**TOWN OF PLYMOUTH
PLYMOUTH MUNICIPAL AIRPORT**

CONSTRUCT, MARK, AND LIGHT TAXIWAY 'E' EXTENSION (APPROX. 500' X 35')

AIP No. 3-25-0042-53-2021

ADDENDUM No. 1

G1.2

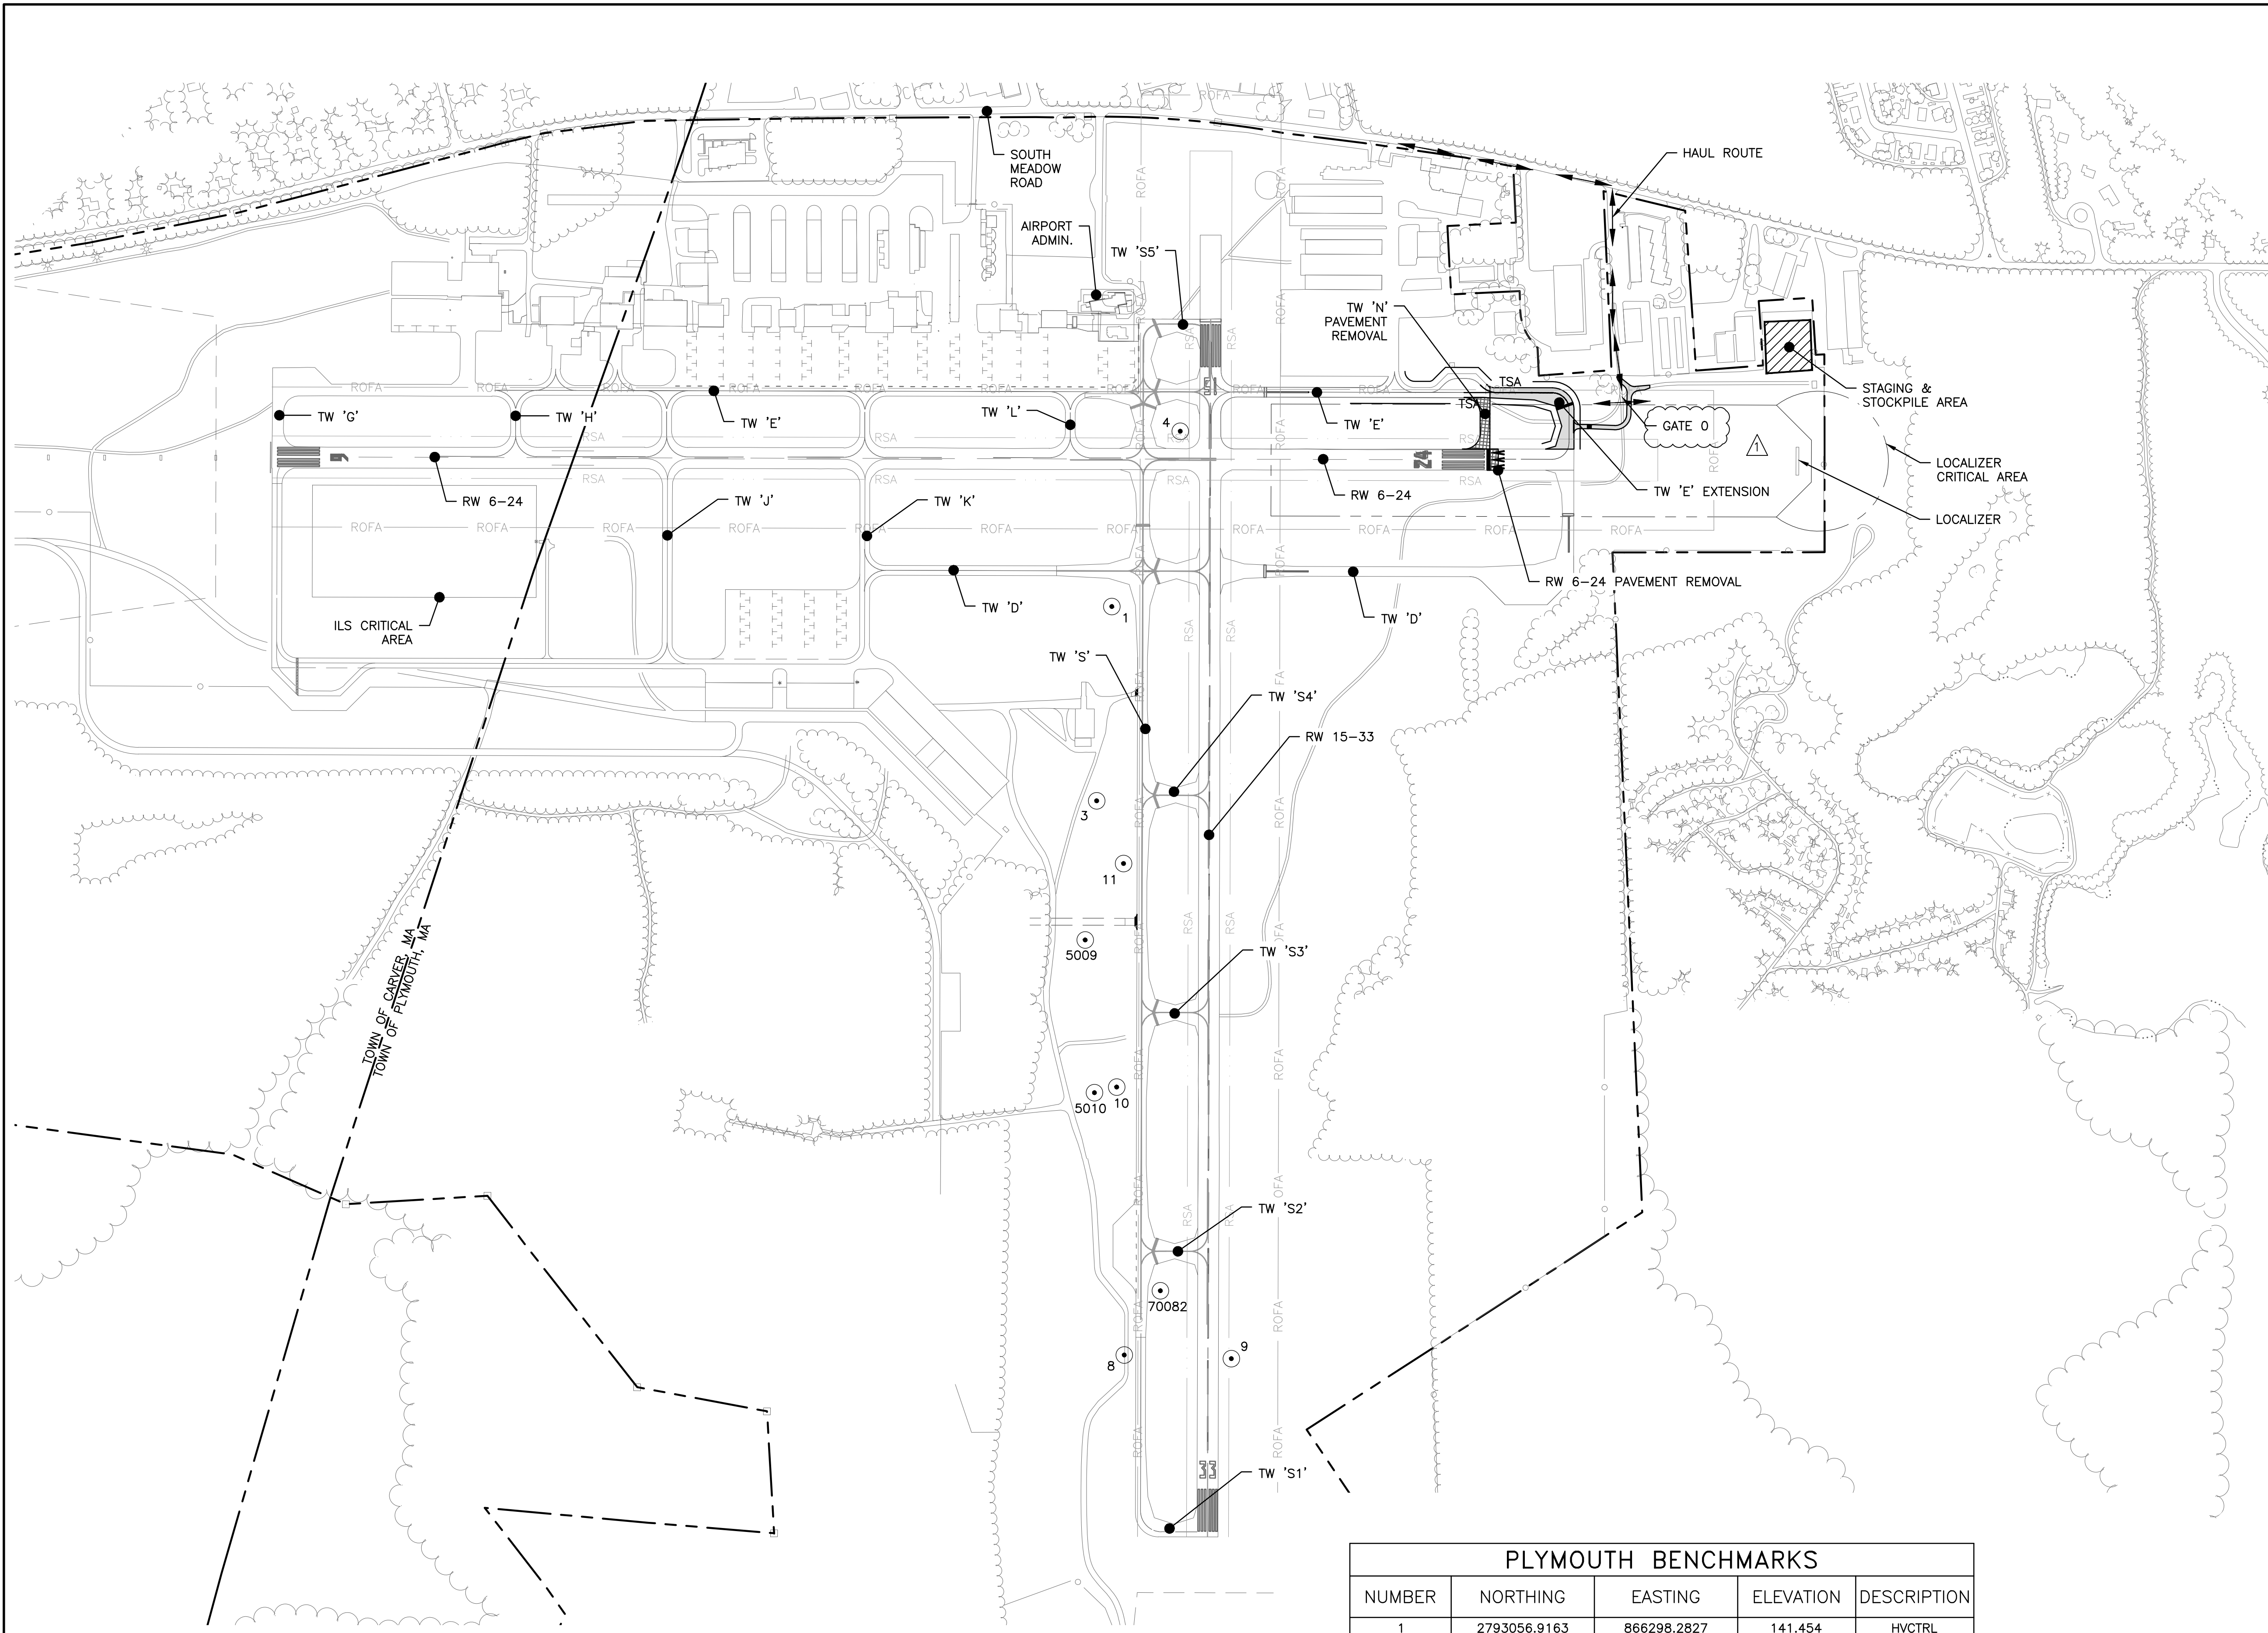
1. Drawing G1.2 has been revised to correct the gate number shown on the plans.
2. Drawing G1.3 has been revised to correct the gate number shown on the plans.

**DEMOLITION PLAN
(1 OF 2)**

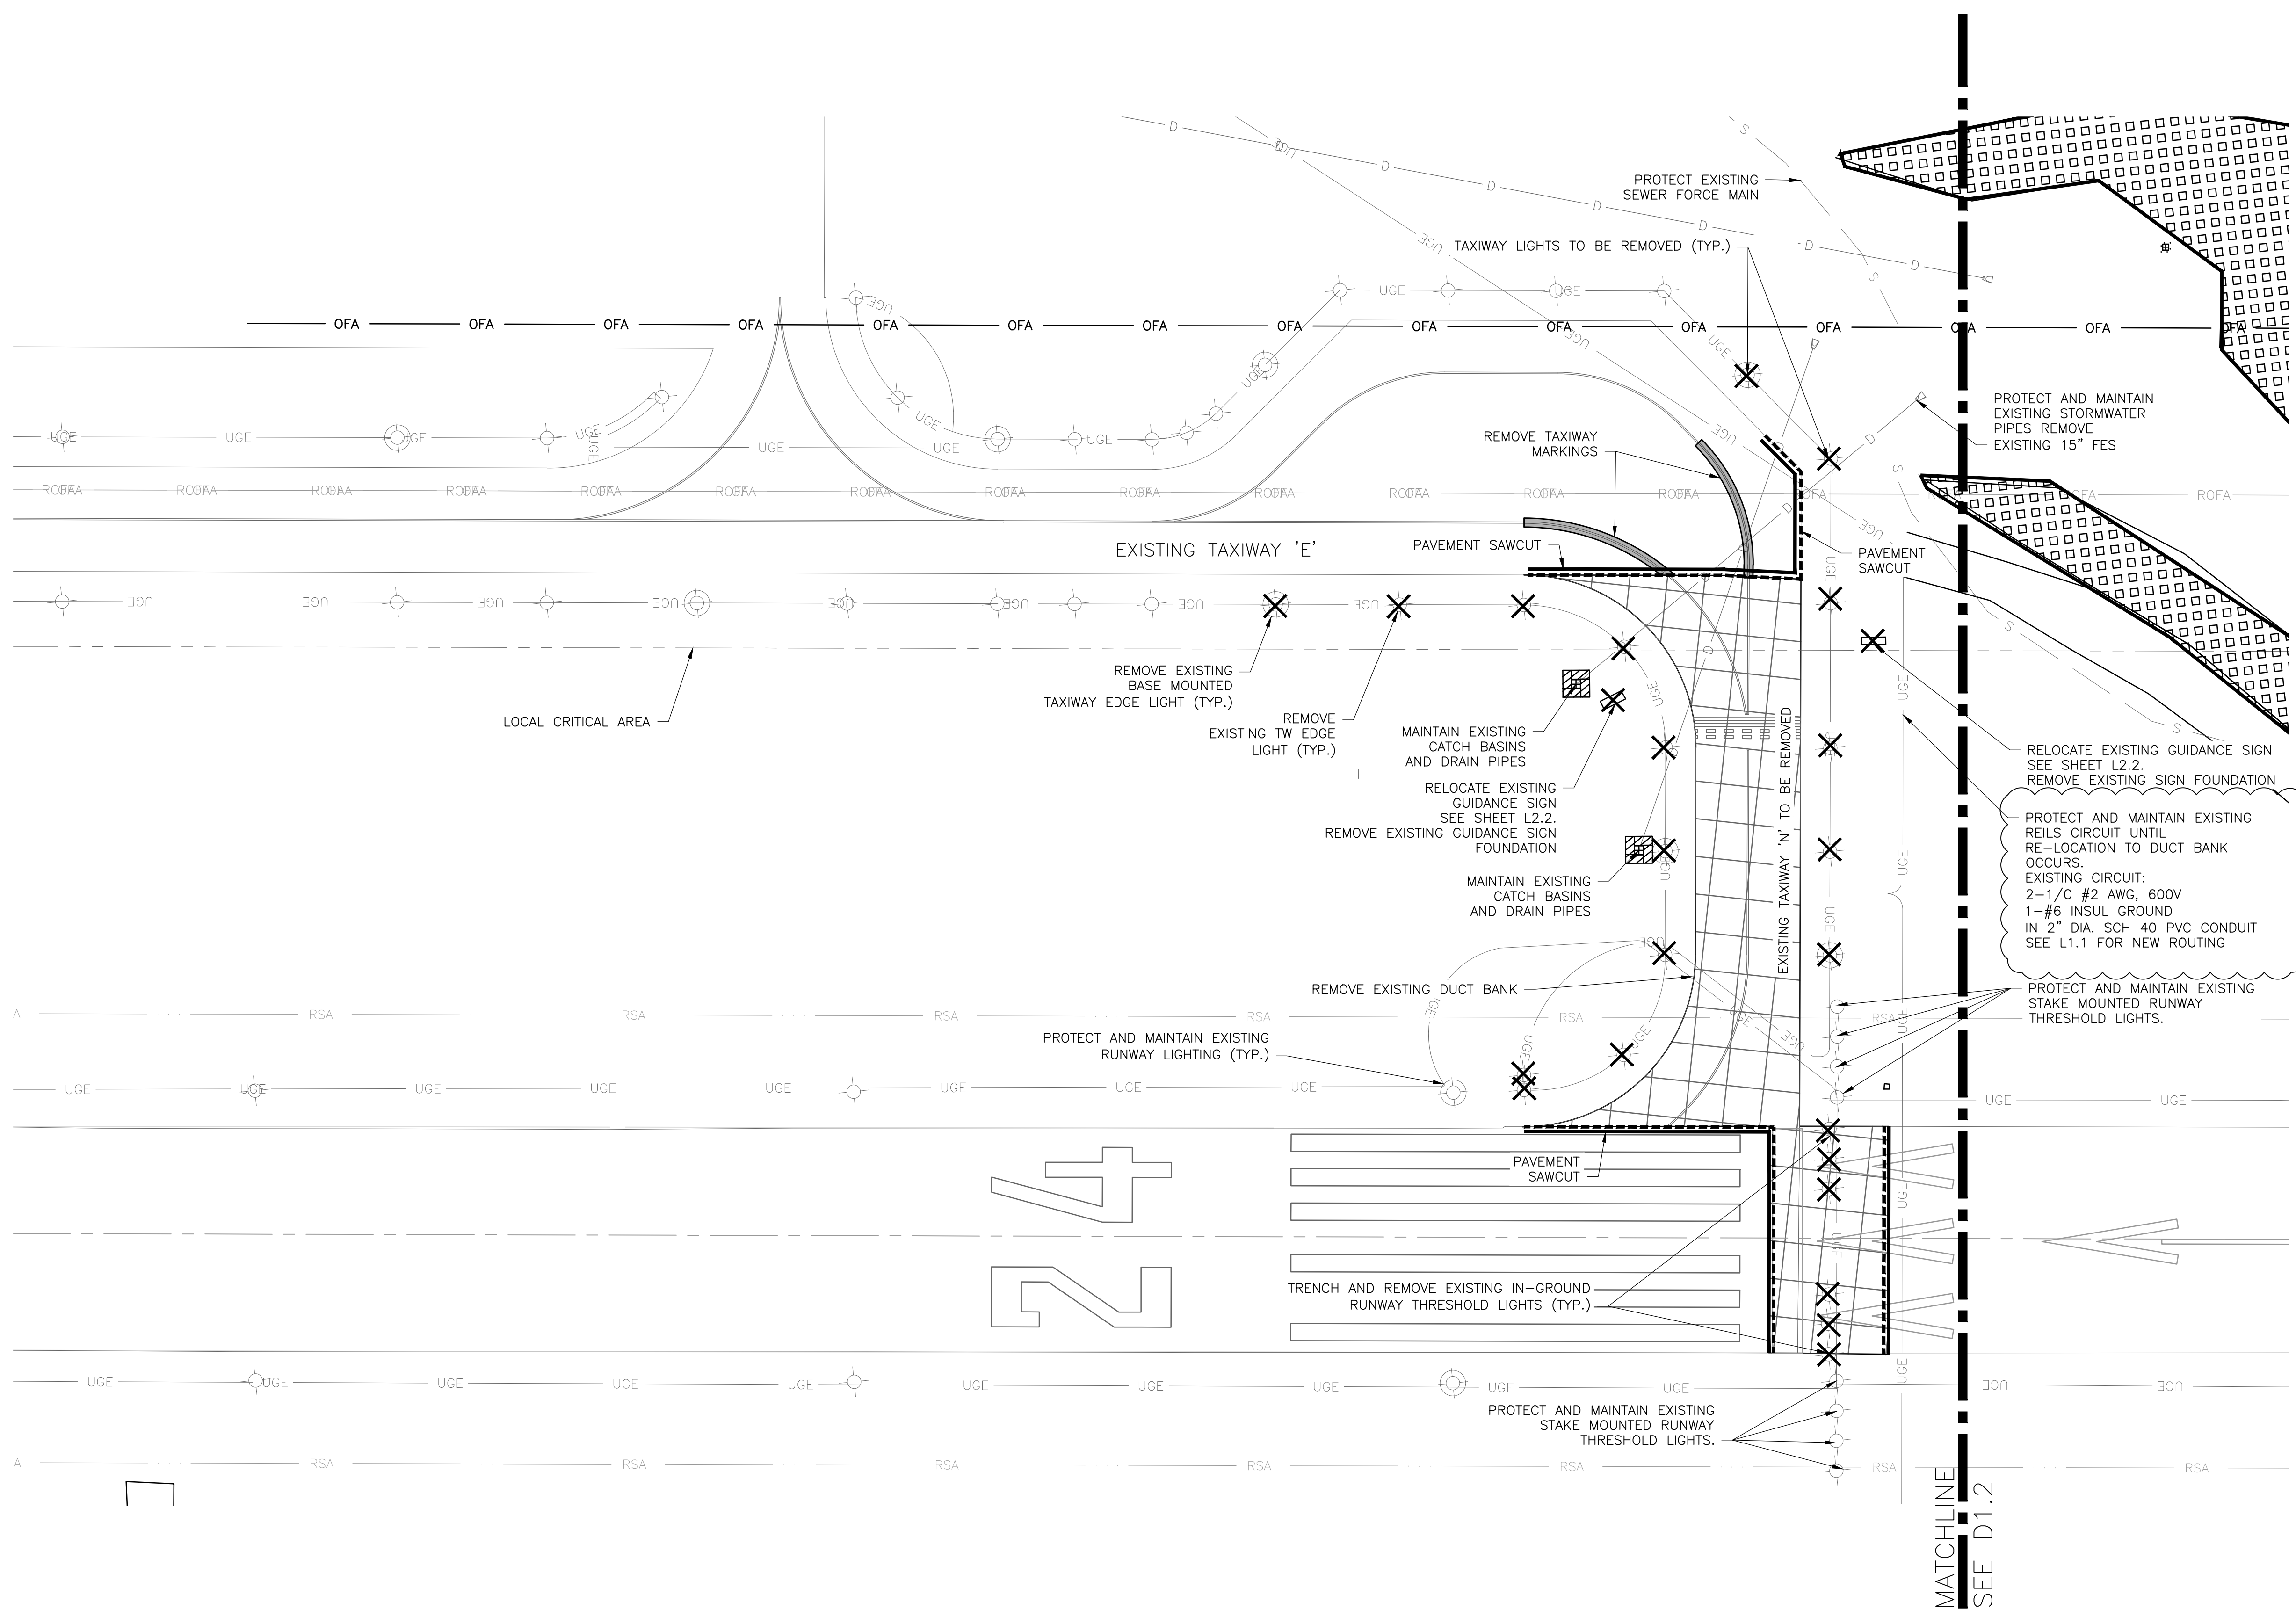
5. Drawing D1.1 has been revised to define existing REILS Circuit.
6. Drawing D1.2 has been revised to clarify existing fence removal area.
7. Drawing L1.1 has been revised to define routing of REILS Circuit through new duct bank, and modification of the proposed location of the associated duct bank. Sign 6 location has been added
